**PROPERTY AT 48 VICTORIA ROAD AND 2A-2B GORDAN ROAD, ROZELLE
SSD-27208140**

We write in response to the **SSD-27208140**, for the St Aloysius College (SAC), Rozelle Campus. Specifically, this letter and attachments provides a response to the additional Request for Information (RFI) dated 27 May 2022. This RFI responds to the meeting held with Inner West Council and the Department of Planning and Environment (DPE) on the 23 May 2022. The applicant, St Aloysius College, and its specialist consultant team have reviewed and considered all matters raised in this RFI, which relate to traffic and heritage. **Table 1** below provides a detailed response to the key matters raised and outlines the proposed amendments to comply with these matters.

TABLE 1. RESPONSES TO DPIE SUBMISSION

Figure 1: Shuttle Bus – gate encroachment. Source: TAIA submitted by the applicant.

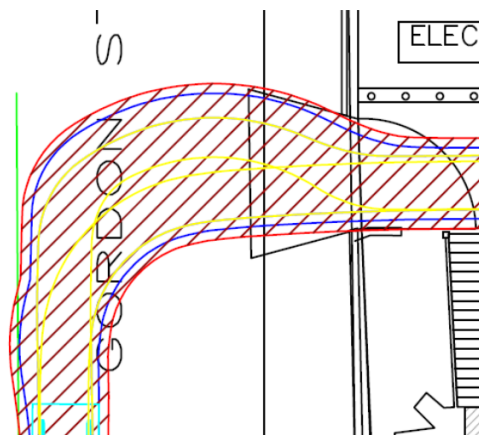
<p>2. Shuttle Bus Swept Paths</p>	
<p>As shown in Figure 1 below, the swept paths show that the manoeuvre is very tight, and the gate encroaches within the 300mm clearance bands either side of the vehicle. Further investigation should be undertaken to explore whether there is scope to widen the entry gates and driveway.</p>	<p>The updated swept path provided within Appendix H of the TAIA report (Appendix 2) shows that there is sufficient width of the driveway to accommodate both the body of the vehicle and the 300mm clearance on either side of the vehicle (red line) which meets the requirements of AS 2890.2 (2018).</p> <p>This is addressed in further within the TAIA (Appendix 2) and traffic response (Appendix 3).</p>

Figure 2: Swept paths - bollard and kerb: Source: TAIA submitted by the applicant.

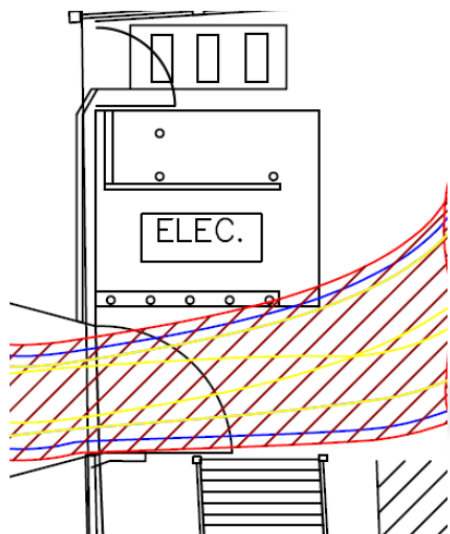
As shown in Figure 2 below, the swept path also details that the shuttle bus will impact a bollard protecting the electricity substation and drops off the edge of the kerb shown circled in red (Figure 3). Further investigation should be undertaken to explore whether there is scope to set the kerb back and to relocate the bollard to allow for better manoeuvrability of the shuttle bus.

The swept path analysis has been amended and is presented in Appendix H of the TAIA (**Appendix 2**). This updated swept path analysis shows that the shuttle bus can manoeuvre clear of the bollards, with a 300mm clearance on either side of the vehicle.
